Staff Report & Recommendation

Design Review Board

DATE: June 7, 2022

SUBJECT: **DRB22-0814, a.k.a (DRB20-0549, DRB17-0198), 1733-1759 Purdy Avenue and 1724-1752 Bay Road**

SOUTH WEST PERSPECTIVE

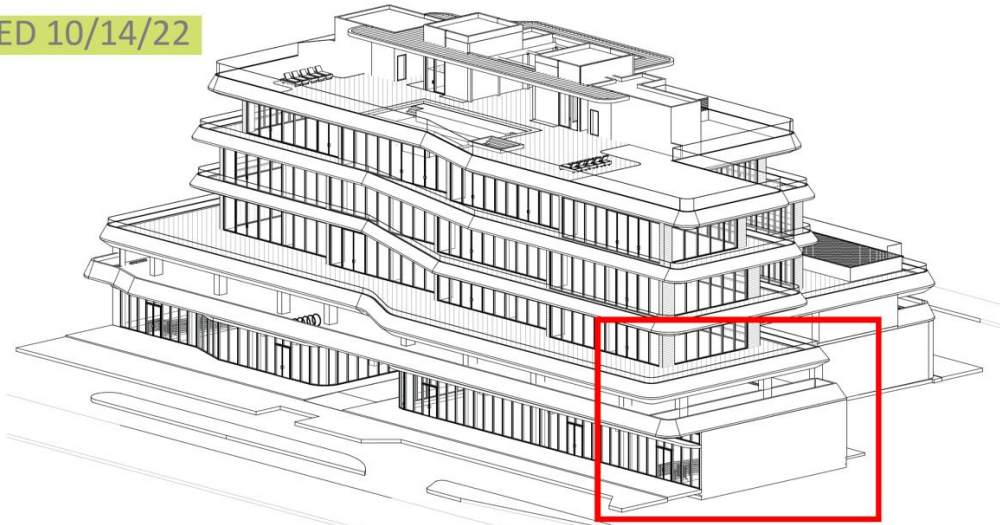
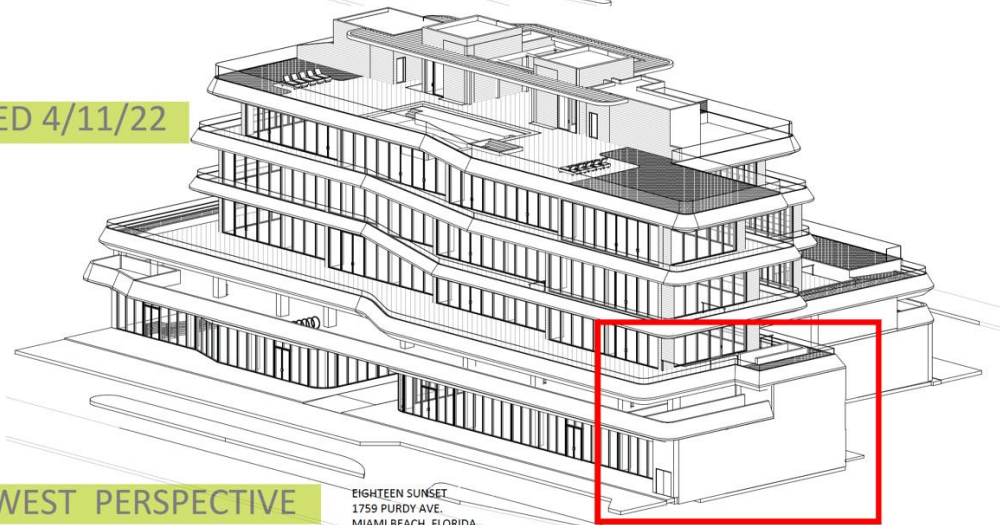
As indicated by the applicant, while in the building permit review process, an added egress stair was required to be provided from the third level outdoor terrace to the street, due to lifesafety requirements. The changes proposed can be visualized best in the below 3D drawing submitted with the application. The additional renderings provided with the application, further show the relationship of the proposed changes with the abutting building to the south.

As the new stairwell enclosure does not directly impact the larger windows and balconies of the abutting building, staff has no objections to the applicant's proposal and would recommend that referenced condition of the final order be amended as follows:

The garage level parking (second floor), shall be set back a minimum of ten (10') feet from the south property line, with the exception of the egress stair in a form substantially as indicated in the amended application reviewed and approved by the Board on June 7, 2022. The entirety of such setback area provided (the roof of the ground floor) shall be open to the sky from this level upwards, and shall be re-designed to include a decorative wall, hardscape, landscape planter or landscape features in order to create a buffer between the garage and residential units of the building to the south, in a manner to be reviewed and approved by staff.
